Subject: UNABLE TO LOWER REAR SEATBACK WITH REMOTE HANDLE / SEATS HARD TO LOCK	Bulletin No: 09-042/12
	Last Issued: 11/07/2012

2013 CX-5 vehicles equipped with a 4:2:4 split type rear seat with VINs lower than JM3KE*****102961 (produced before Jan. 20, 2012)

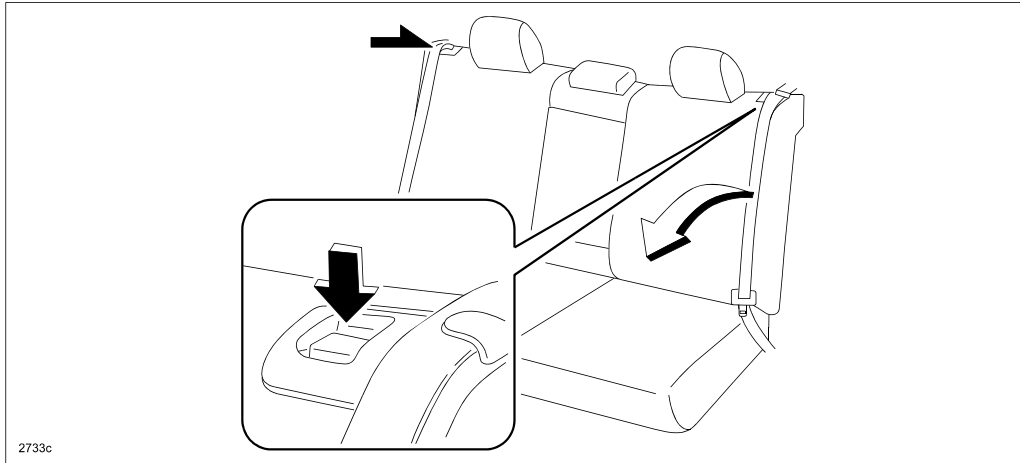
Some vehicles equipped with a 4:2:4 split type rear seat may be unable to lower the rear seatback (A) when pulling the left (B) and/or right (C) remote handles. Also, the seatbacks may not fully latch (lock) when placed in the upright position.

This concern may be caused by an incorrect seatback remote cable adjustment position. The current adjustment position may not provide enough tension for the cable to unlock the seatback latches.

The position of the seatback remote cable adjustment has been changed to the center position at mass-production.

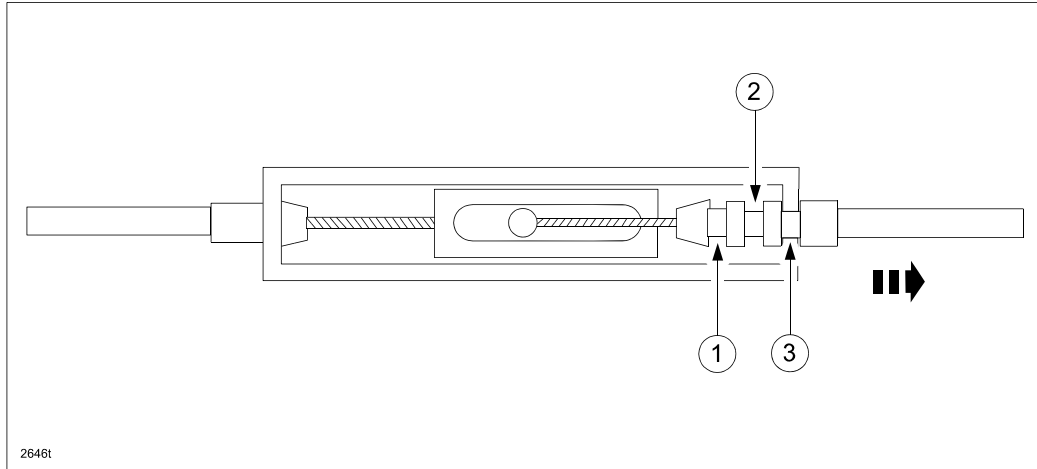
- Using a small flathead screwdriver, pop open the affected remote cable adjuster housing and check the current cable adjustment setting position (1, 2 or 3) as shown below.

NOTE: Cable adjustment setting position “3” is the factory setting for vehicles produced before Jan. 20, 2012.

- Pull the cable out of the housing and change the setting to position “2”, then snap the remote cable adjuster housing closed.
- Using the appropriate remote handle lever, check the seat back for proper releasing and locking operation.

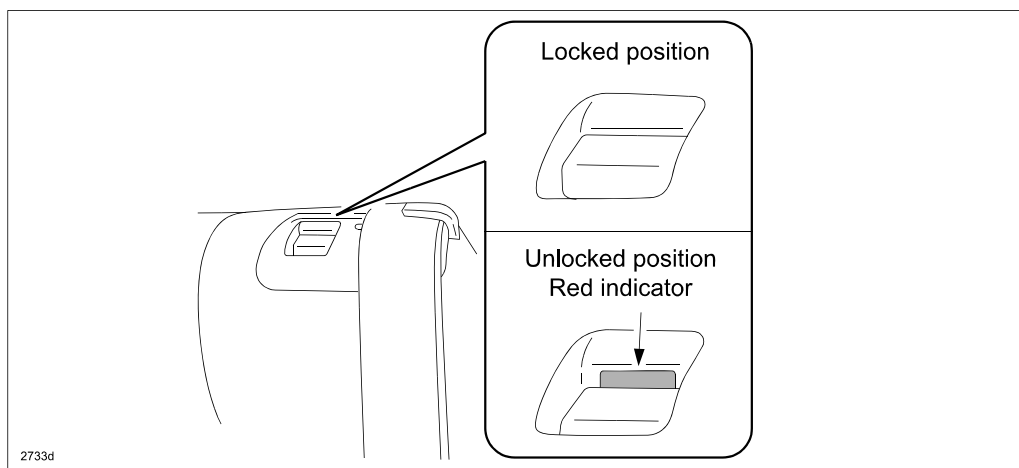
- If changing the setting to position “2” does not fix the concern, change the setting to position “1”, but make sure the seat back can be fully and properly locked after the adjustment is made.
- The red seat knob indicator must be visible when the seat back is in the unlocked position (seat knob down) and must not be visible when the seat is fully locked (seat knob up).
